2. CASE 22.022, 59 PARADE STREET, House, c1870 (ARMORY)

Project: Two Family Residence
Address: 59 Parade Street, Providence, RI 02909
Date: 12 February 2022
Revised – 17 March 2022
Re: Application Information

NARRATIVE – Scope of Work

EXTERIOR ELEVATIONS

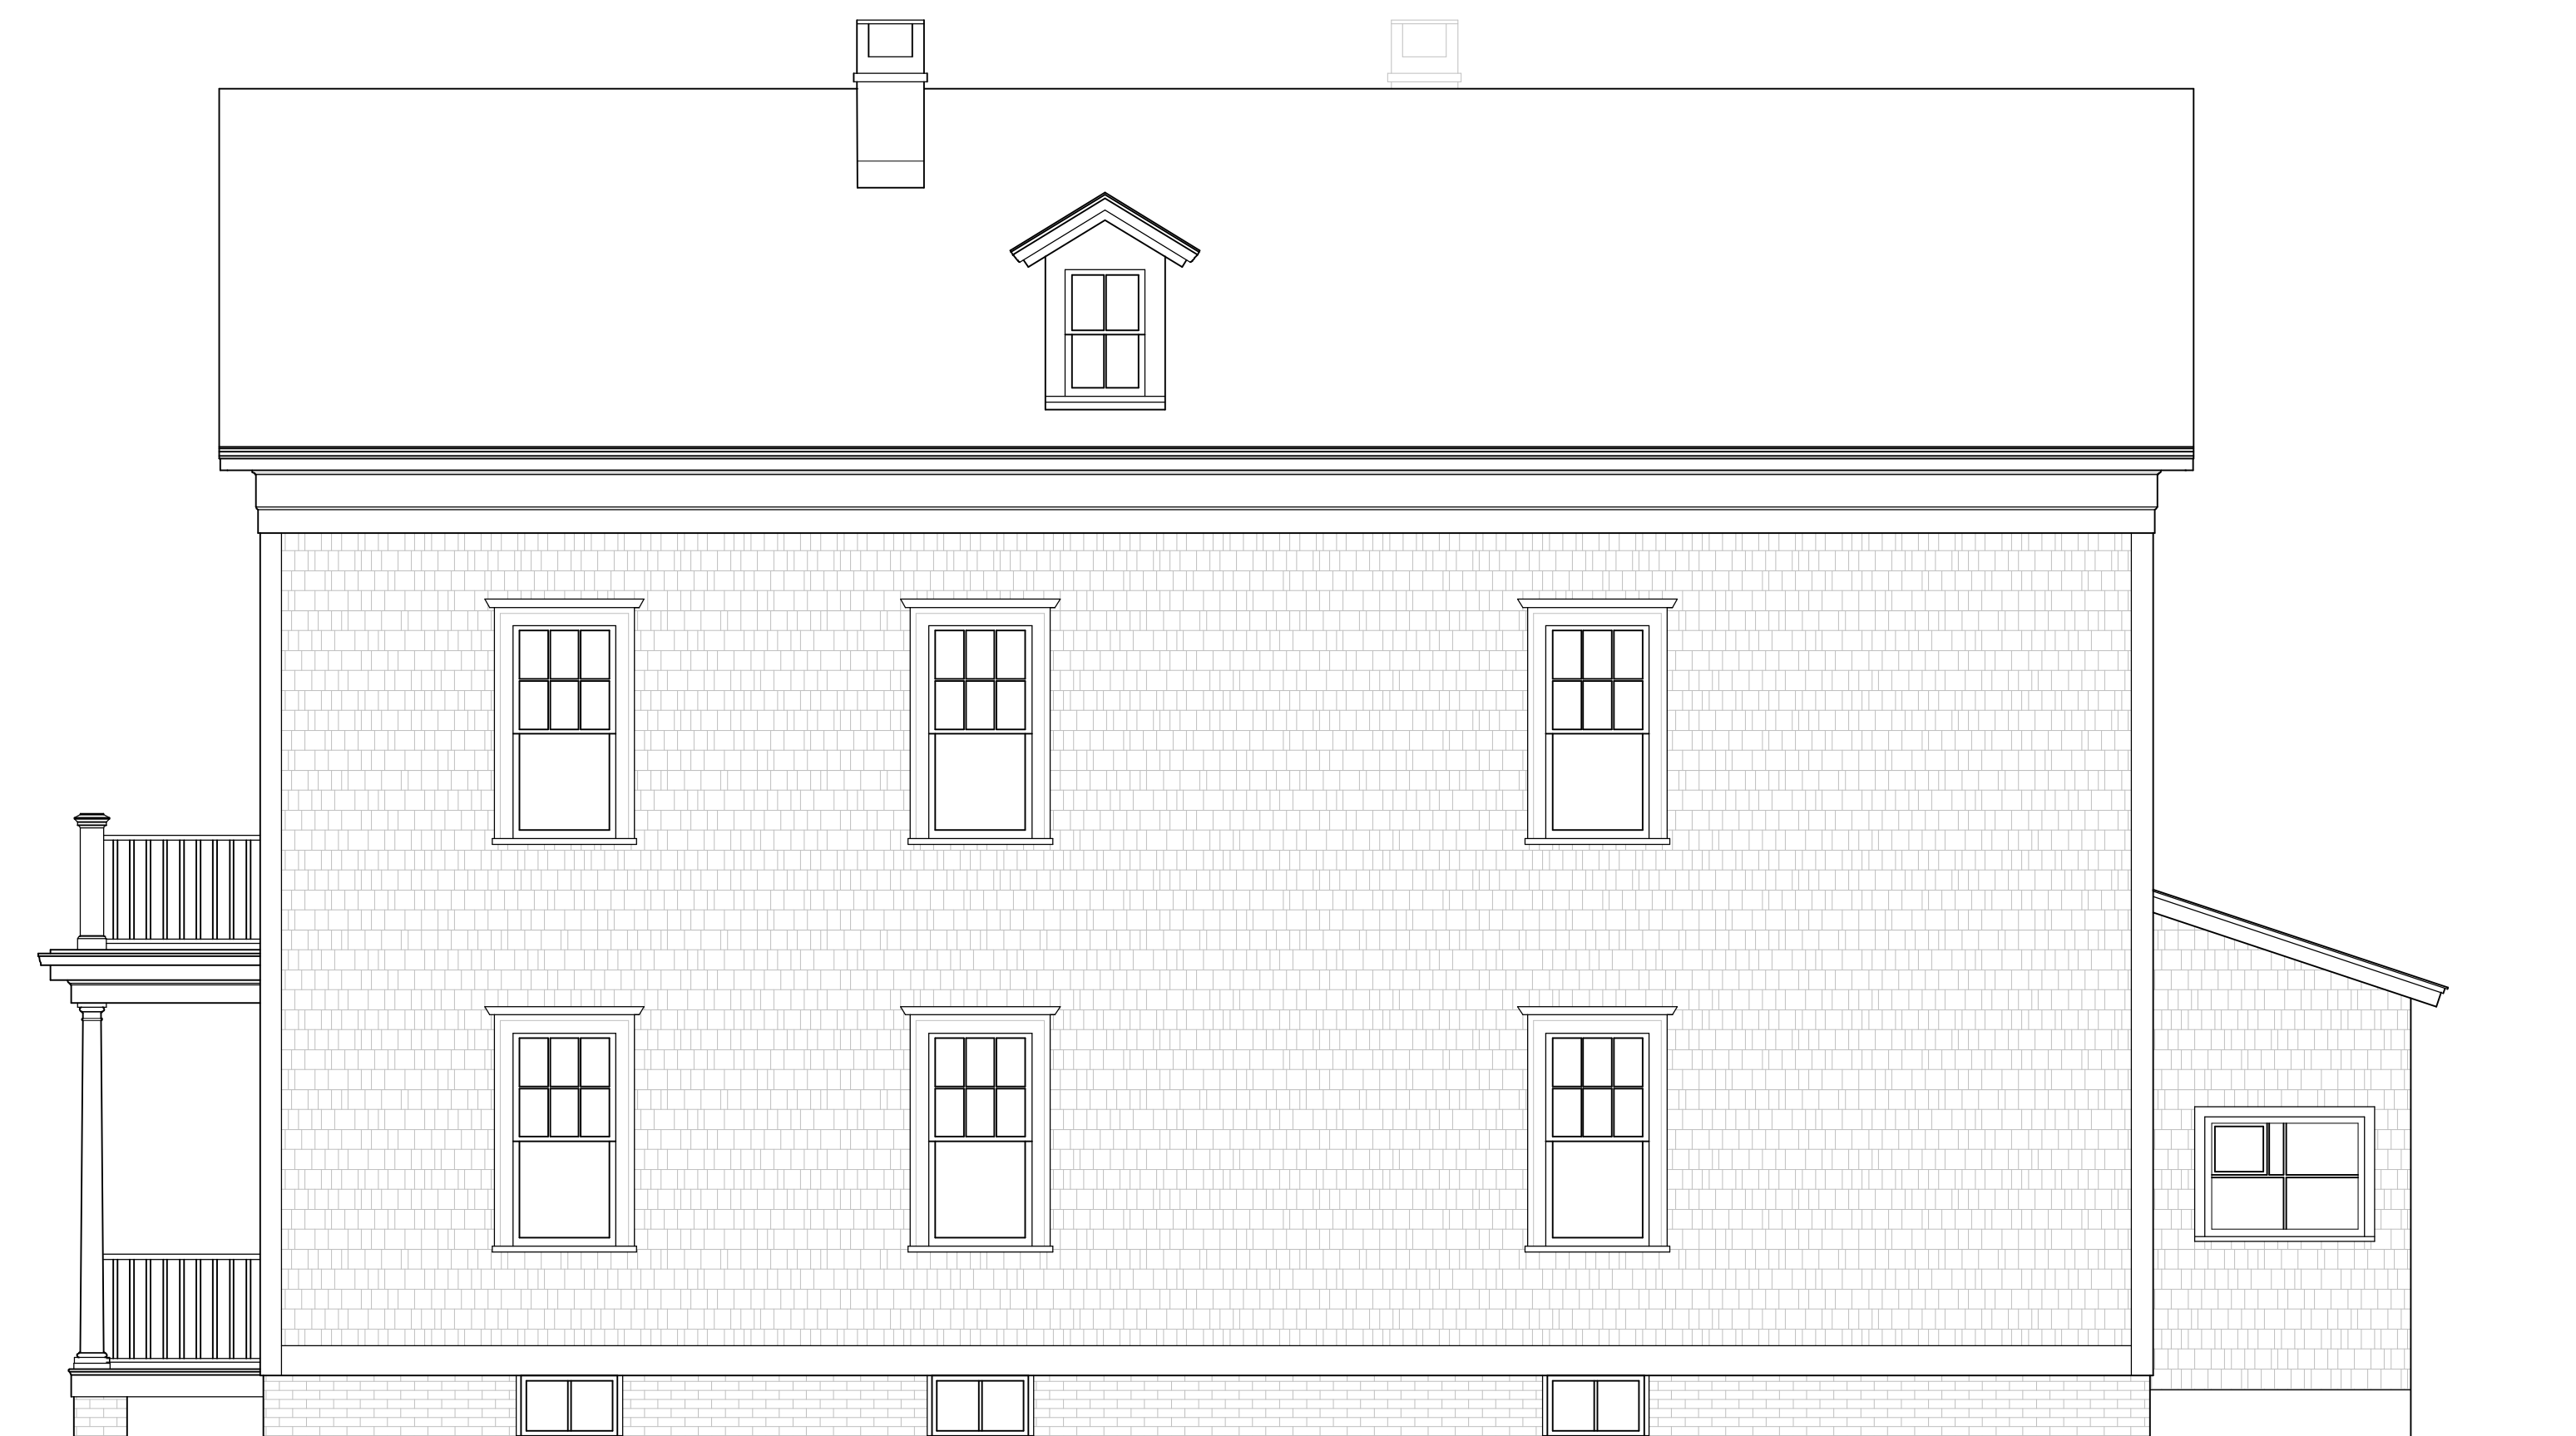
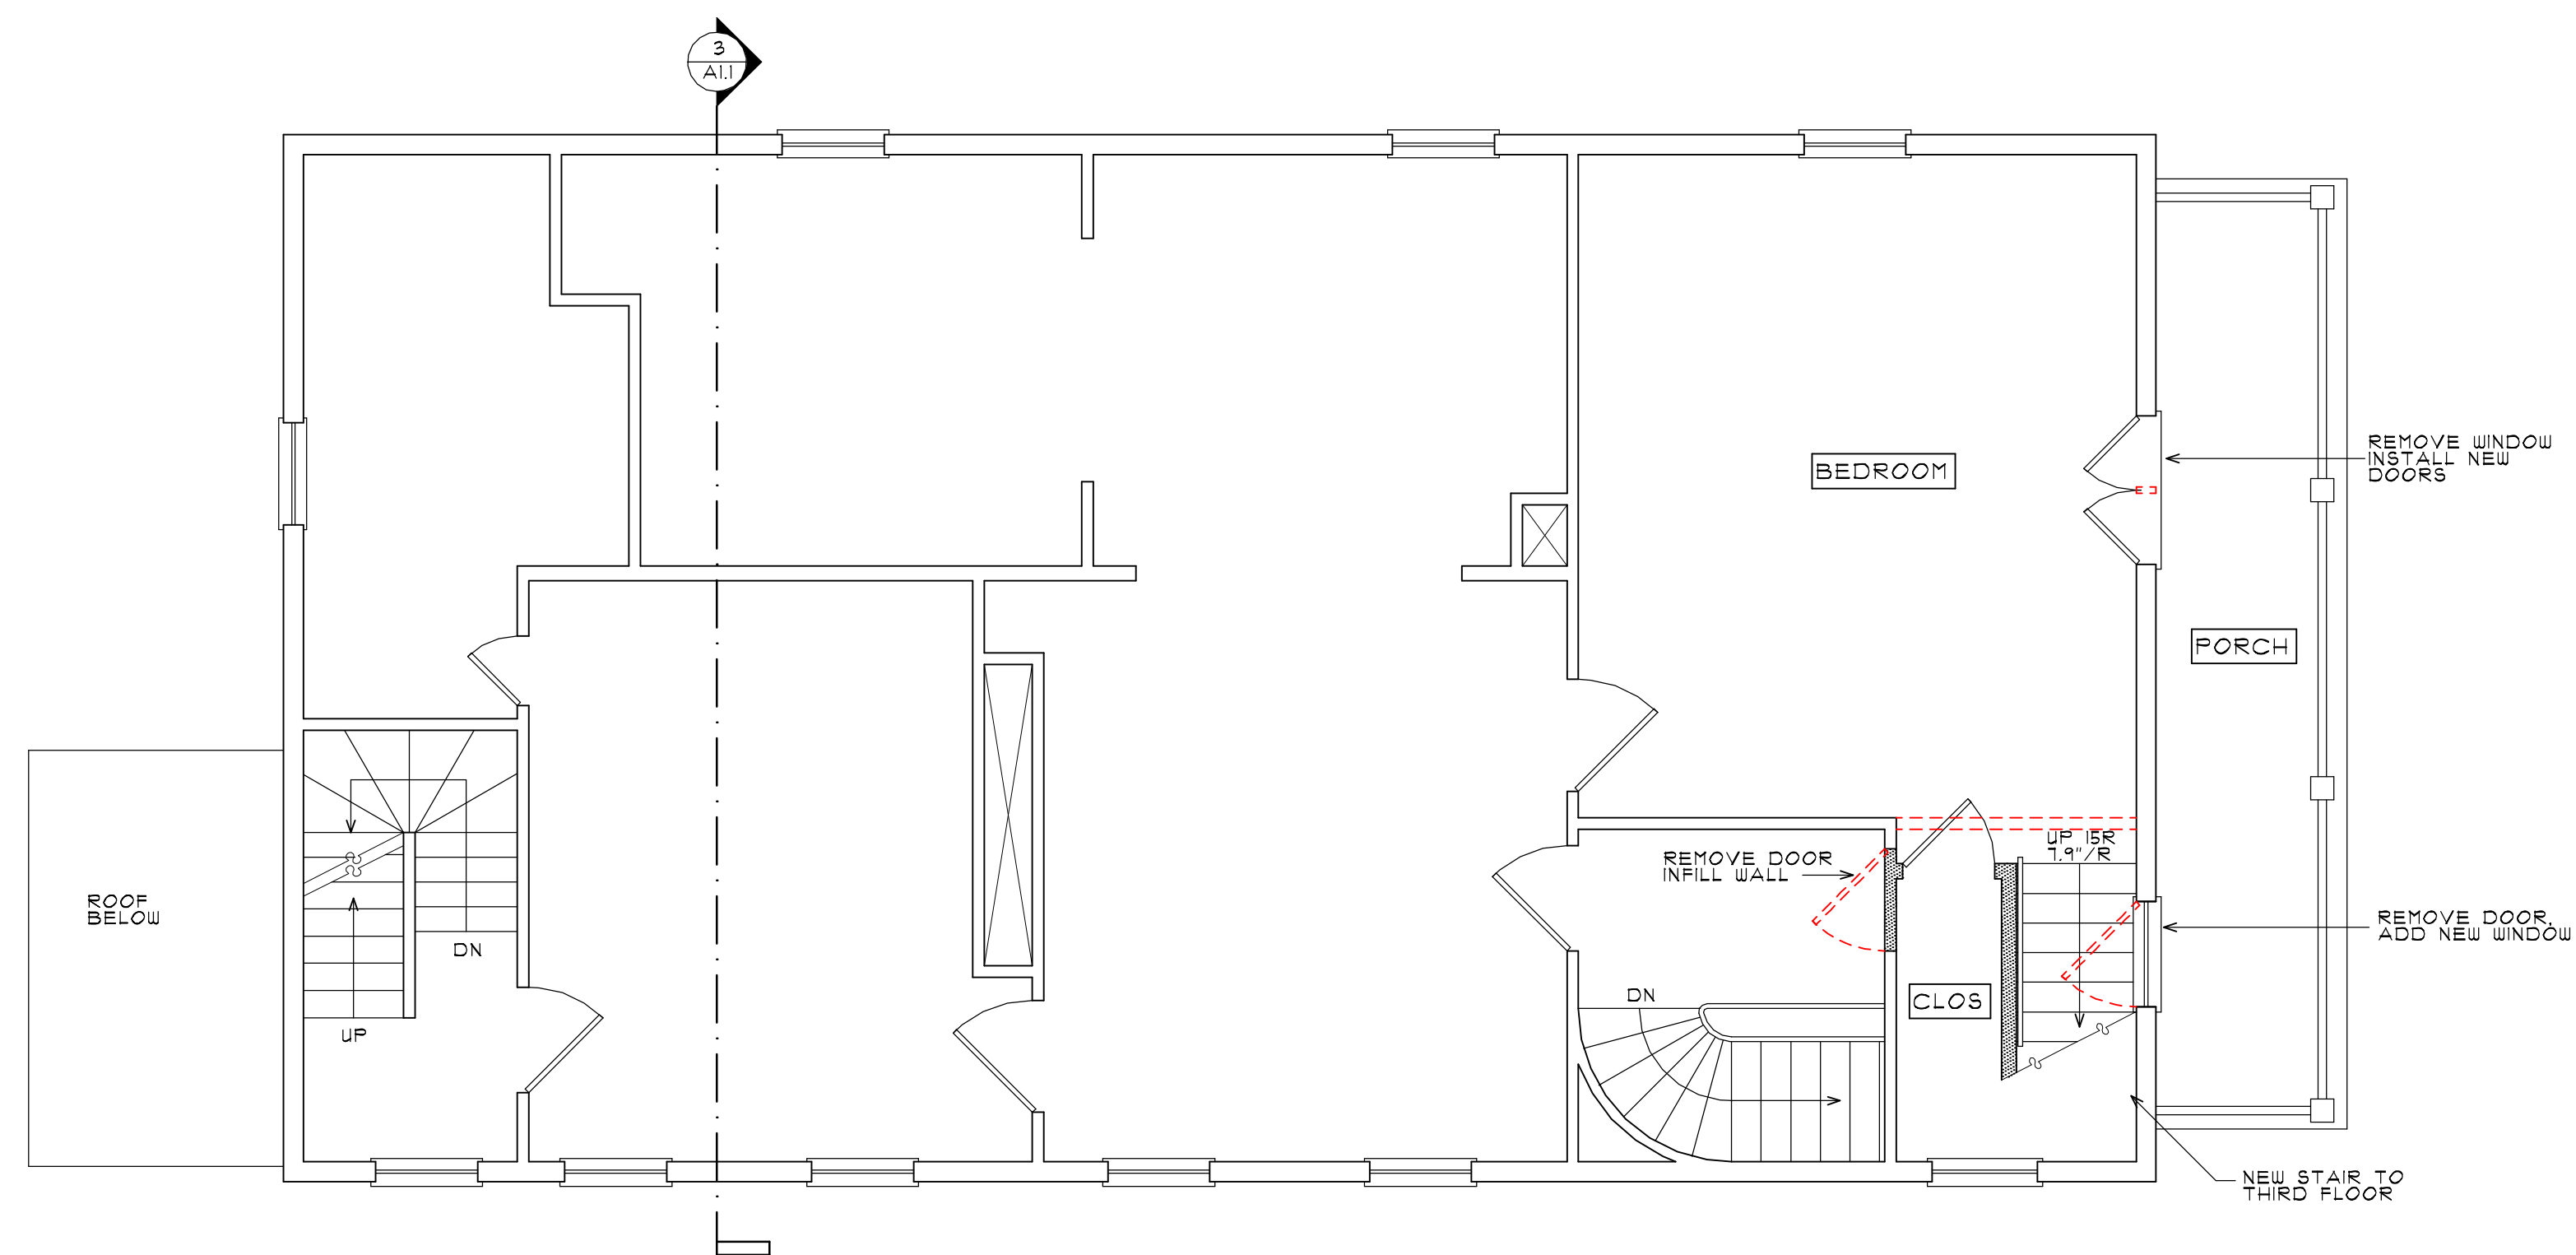
- At the 2/28 meeting the item was continued. At that meeting the Commission had concerns about the proposed screening-in of the porch: how would the details be handled? Would it be a three-season porch, with the screens removed in the winter? Staff noted that it was common for porches to be screened-in as a three-season element. Also concerns about the dormers. Agreement that rearranging the door and windows on the second floor was acceptable. The dormers have been removed from the proposal and skylights have been proposed. The majority of the proposed modifications will be visible from the public rights-of-way; and,
- Revised plans and photos have been submitted.

- a) 59 Parade Street is a structure of historical and architectural significance that contributes to the significance of the Armory local historic district having been recognized as a contributing structure to the Broadway/Armory National Register Historic District;
- b) The application for Major Alterations is considered complete; and,
- c) The work as proposed is in accord with PHDC Standards 8 & 9 as follows: 8) the work will be done so that it does not destroy the historic character of the property or the district; and, 9) Whenever possible... alterations to structures shall be done in such a manner that if removed in the future, the essential form and integrity of the structure and the site will be unimpaired.

Staff recommends a motion be made stating that: The application is considered complete. 59 Parade Street is a structure of historical and architectural significance that contributes to the significance of the Armory local historic district having been recognized as a contributing structure to the Broadway/Armory National Register Historic District. The Commission grants Final Approval of the proposal as submitted having determined that the proposed alterations are appropriate as the proposed alterations are architecturally and historically compatible with the property and district having an appropriate size, scale and form that will not have an adverse effect on the property or district and is reversible (Standards 8 & 9), citing and agreeing to the recommendations in the staff report, with staff to review any additional required details.
